Planning Commission Regular Meeting

Monday, August 24, 2026, 6:30 PM
106 Center Street

Re: 150 Bell Street – Application for RRP
Date: August 24, 2026
From: Jess Long, Planner and Julia Mullin, Community Development Director

Excelsior Good Neighbor Guidelines PLAN Review

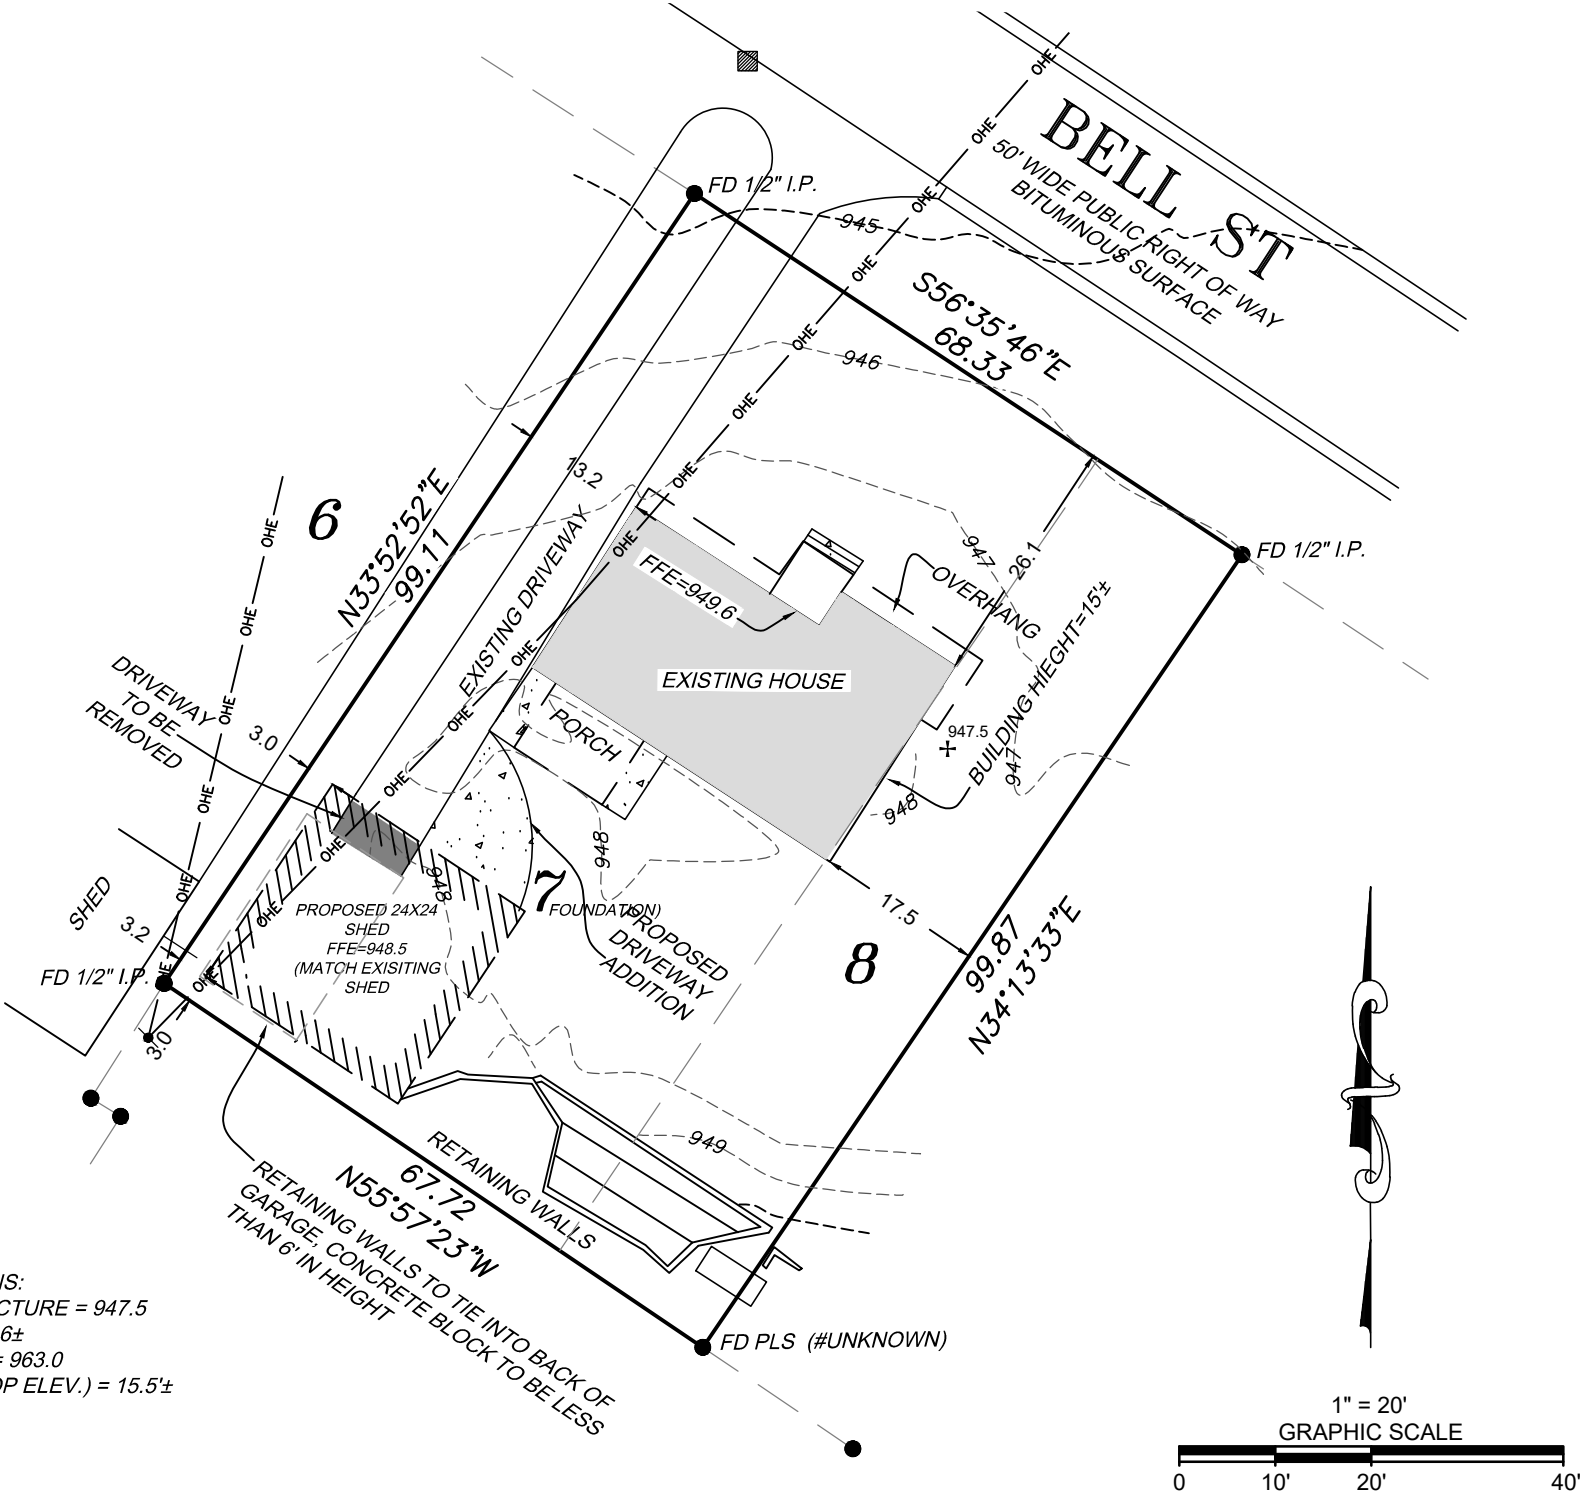
The site has a steep grade up in the rear yard with an extensive retaining wall. Drawings do not clearly show how the proposed structure and retaining wall intersect. Applicant should clarify how retaining wall and garage relate to each other, and how grades and drainage are managed around the rear of the garage.

The side and rear elevations indicates a full-height CMU block at rear of garage. Site plan indicates this wall to be 6-0 high maximum; drawings show it full-height, approximately 8-8. Applicant should clarify.

C. CONCRETE BLOCK AT THE REAR OF THE GARAGE: MUST BE ONLY 6' TALL AND TIE INTO EXISTING RETAINING WALLS, MATCHING EXISTING GRADE.

NW Elevation (West Lake Street)

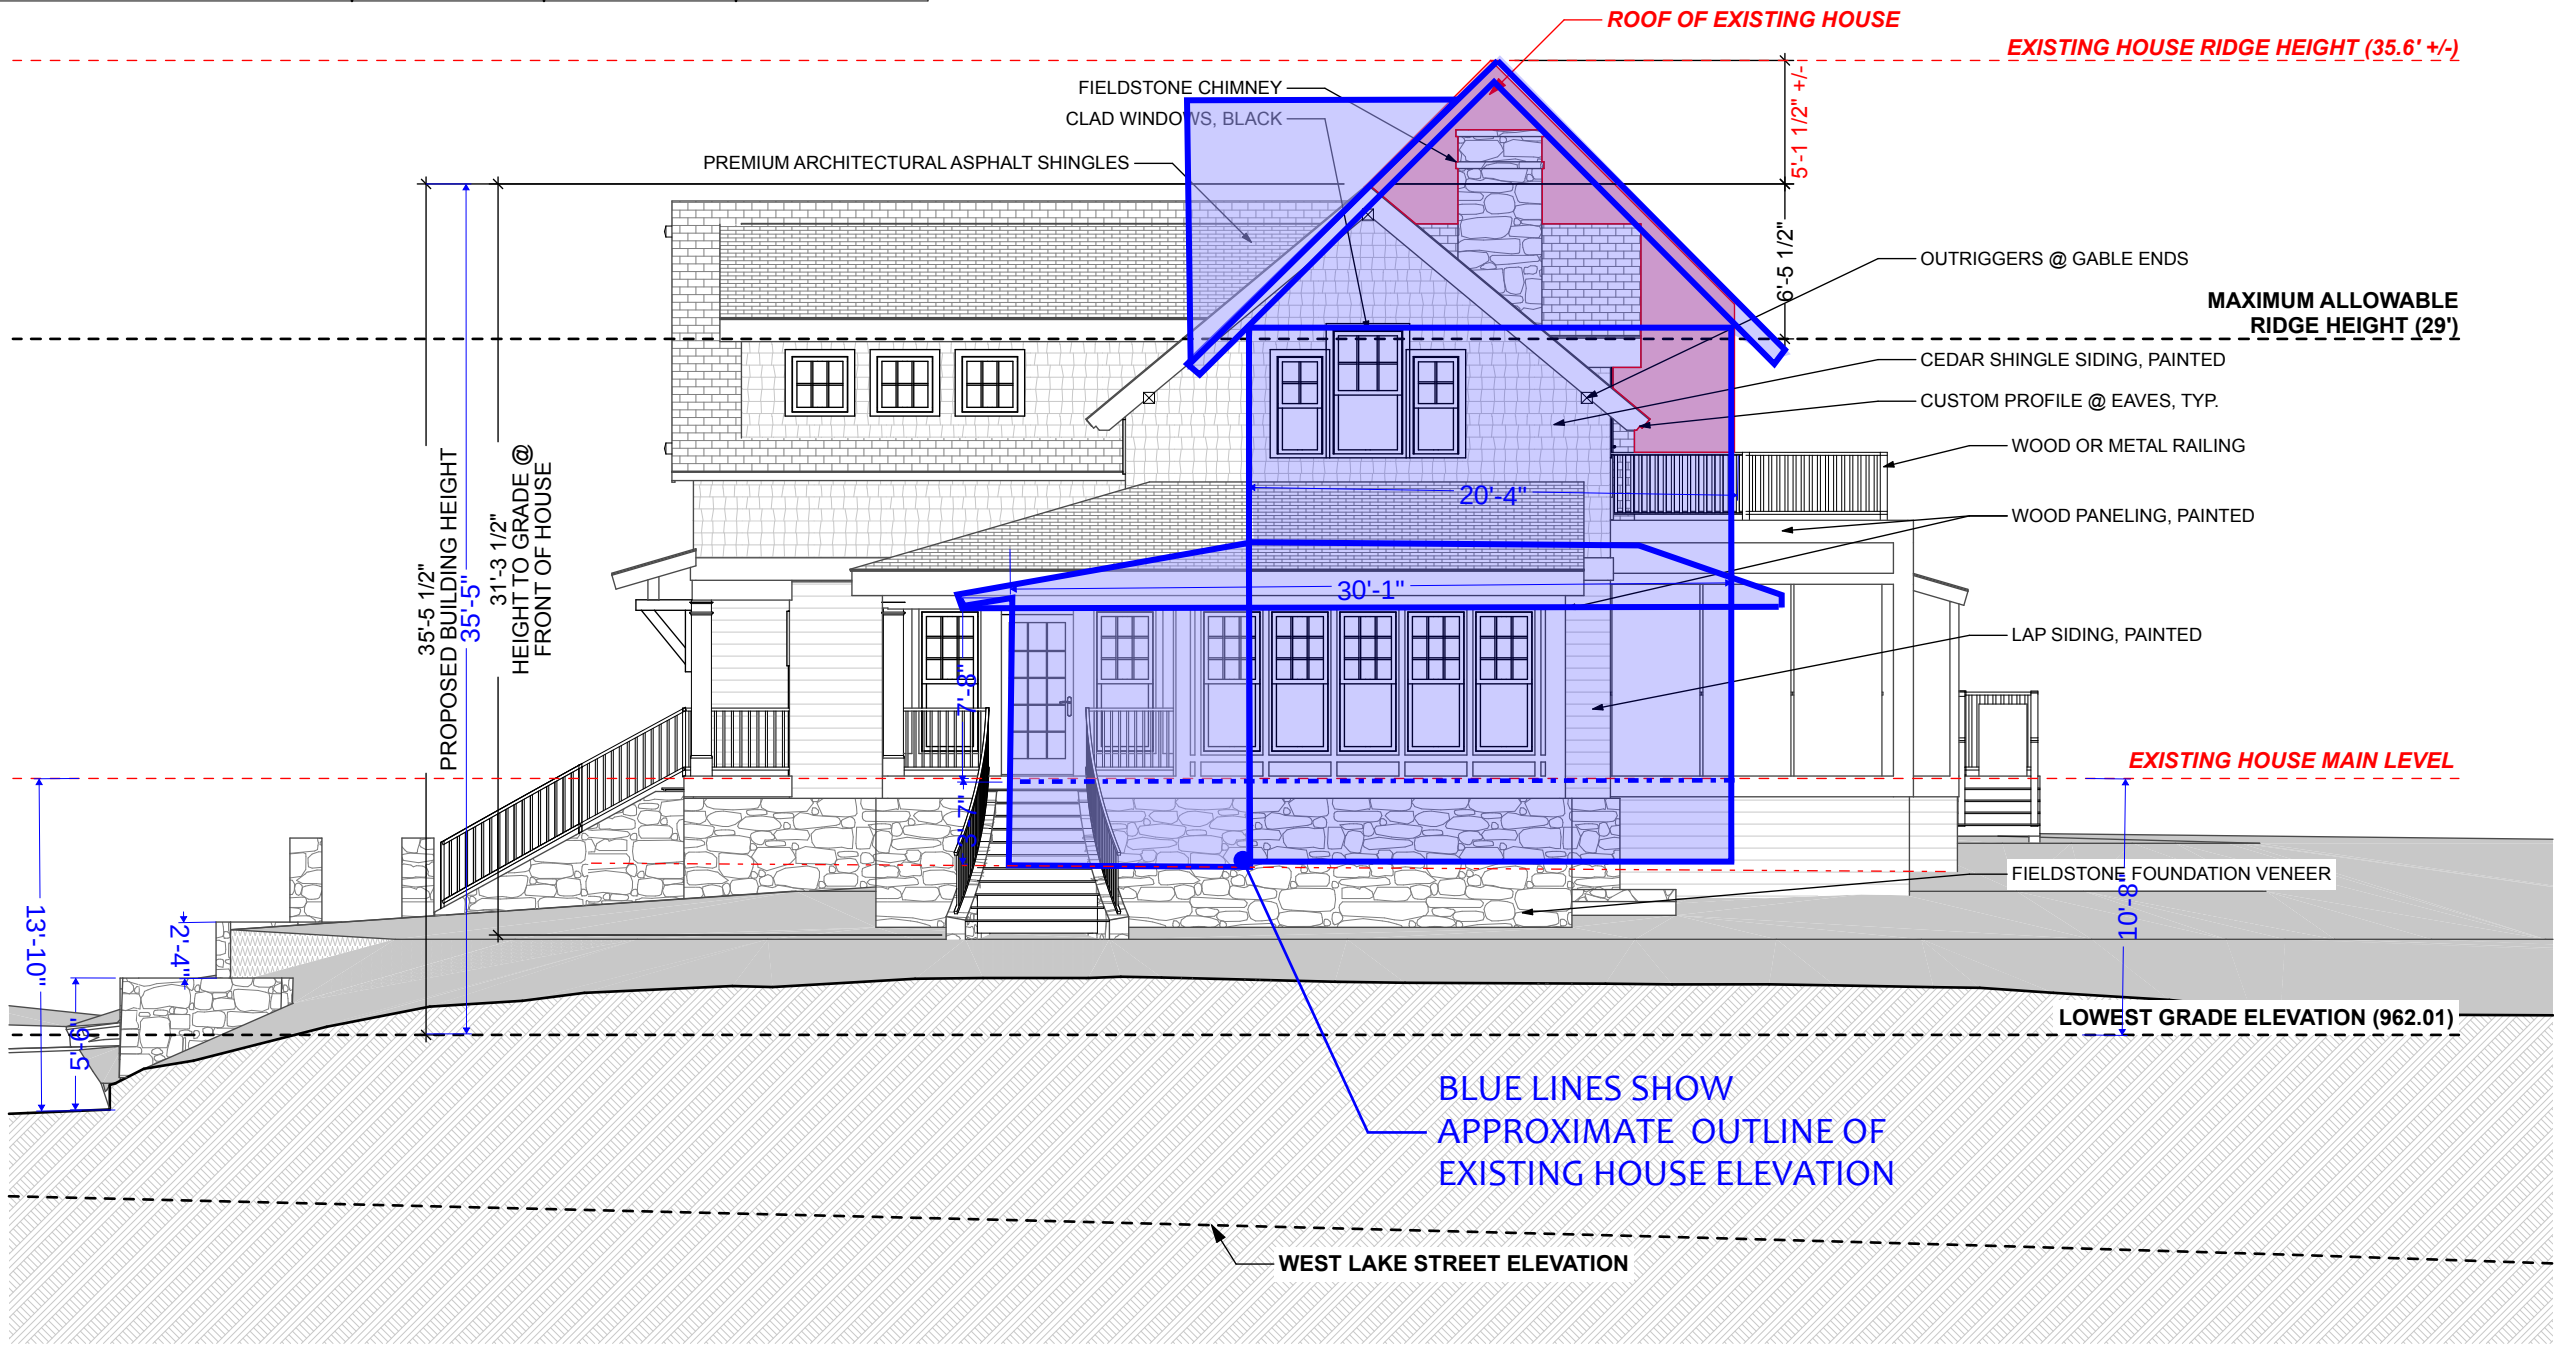
Though the height of the proposed home is lower than the height of the existing, the massing and scale of the proposed design is greater than the existing, and greater than many of the adjacent homes. One notable change is the additional footprint and massing moving 13.6' closer toward Maple Street (an 18.2' setback vs. existing 31.8'). This massing change is emphasized by existing topography and grades, with the main floor (both existing and proposed) set about 13-0 above sidewalk level. The proposed footprint also expands toward W. Lake Street and the neighbor to SE, but these impacts are somewhat diminished by the larger setbacks at those locations. A new, stepped +/- 8-0 retaining wall is proposed along Maple.

Site Plan

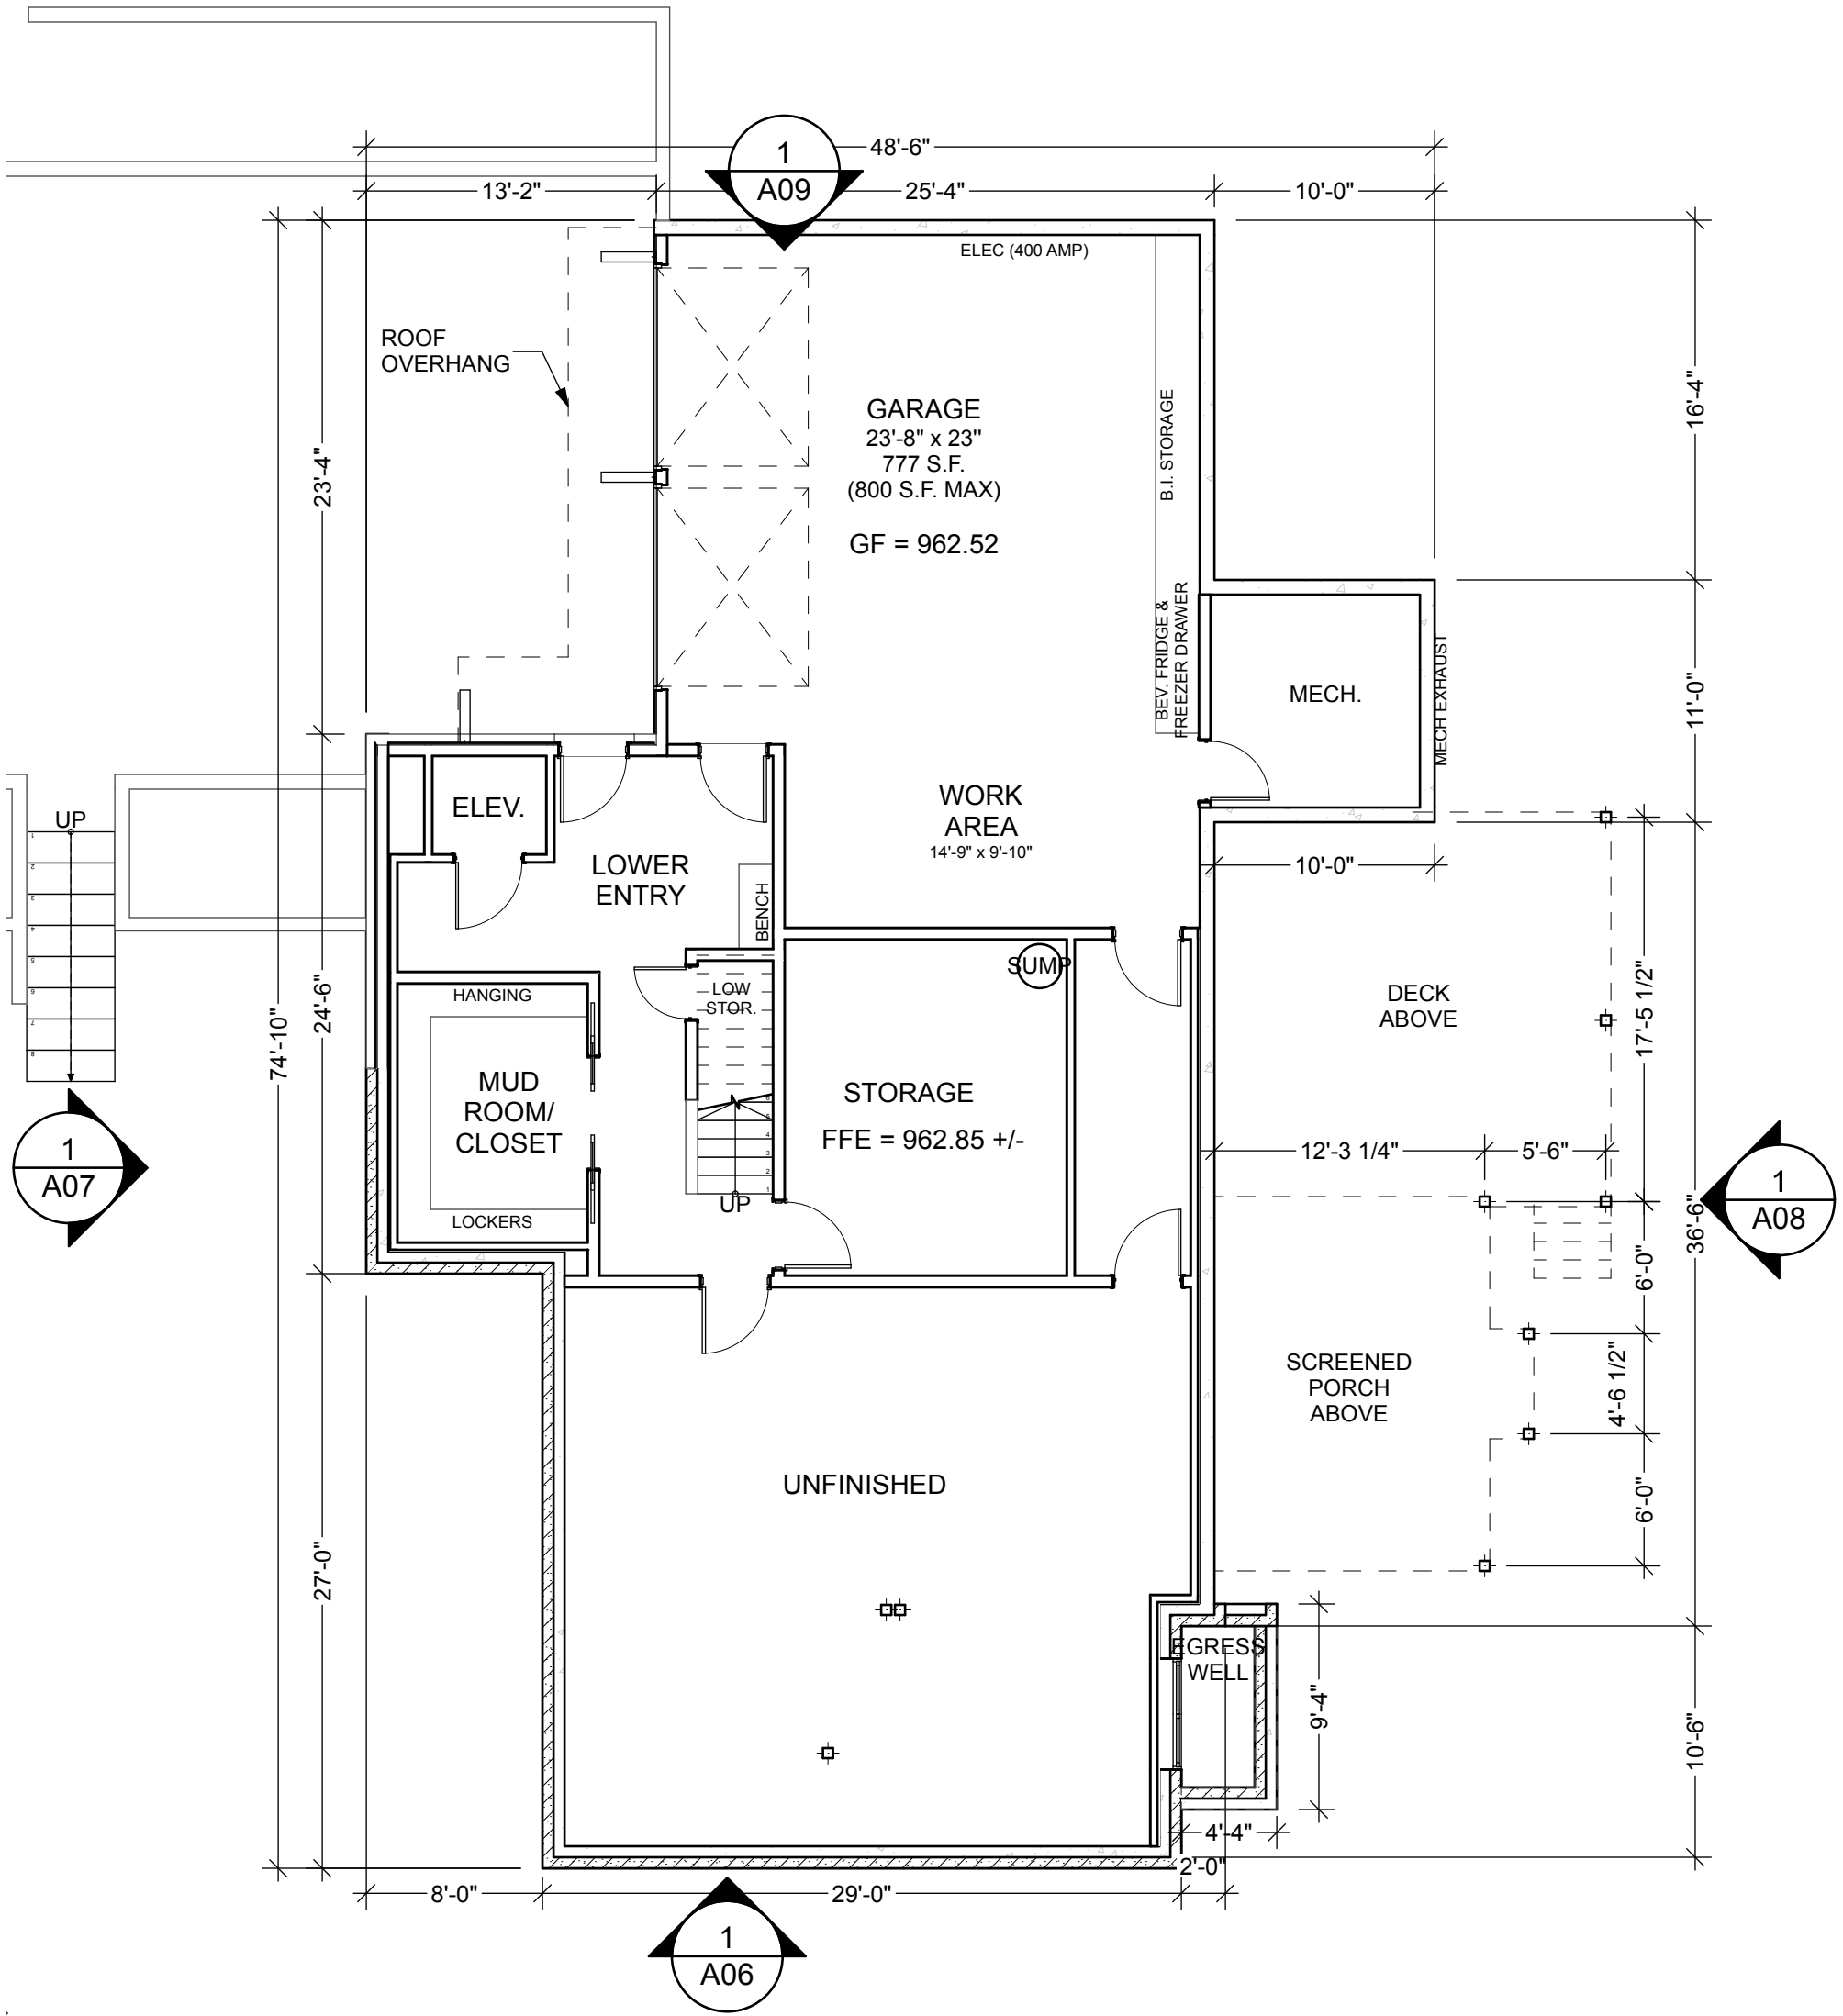
The site has a steep grade, with an existing stone retaining wall along Maple proposed to be removed and replaced with +/- 8-0 high stepped boulder retaining walls (approximate heights appear 5-6 at sidewalk and 2-6: applicant can verify). Applicant should clarify construction of the walls (loose boulders vs coursed stone, or other?). The existing house had both front and side entrance sidewalks connected directly to the public sidewalk at Maple Street; the proposed shows only a Maple-facing entrance sidewalk connecting to the to the driveway.
